Fire Station 22 – Roanoke

Meeting Summary

Schematic Design

The Commission encouraged the team to refine the west façade...

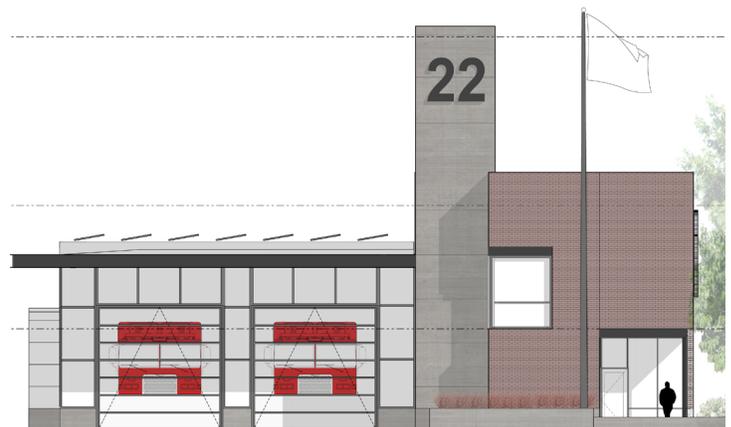
1. Present perspectives of the south façade given that it is visible from the North Capitol Hill neighborhood and 10th Ave E.
2. The west façade is an important and perhaps underexplored part of the design. Continue to refine it with the goal of supporting the concept that the

...to engage the public realm as effectively as the east façade does.

north façade is more veneer than mass. The west façade should have a relationship to the north façade the way the east façade successfully does.

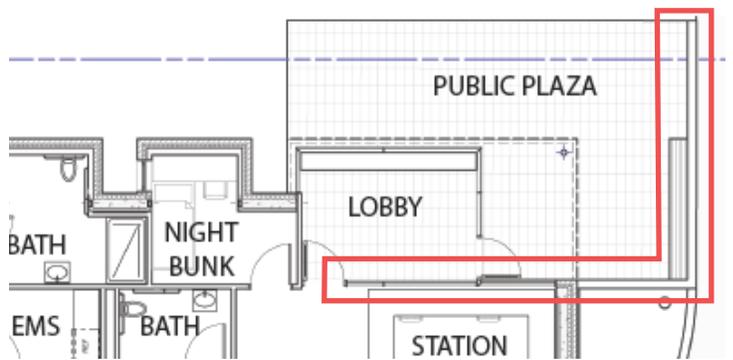
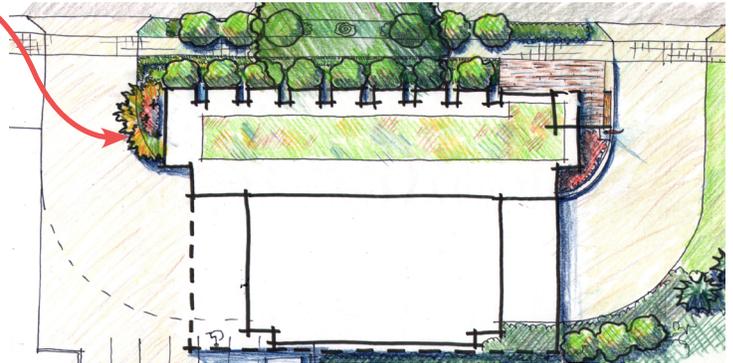
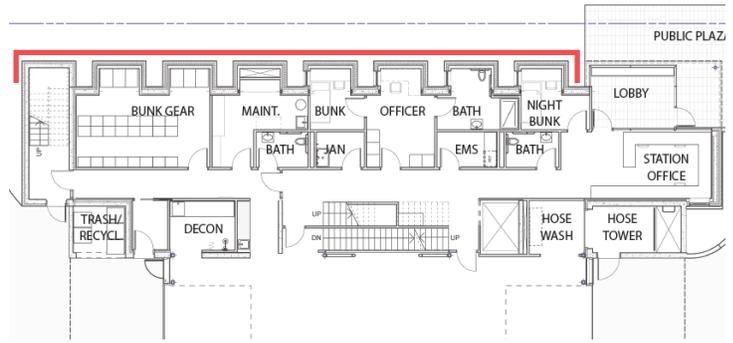
3. Continue to study the potential effects and impacts of the north façade crenellations on interior spaces. The Commission wants to understand clearly that the team has worked with SFD to understand these impacts on circulation and overall programmatic flow.
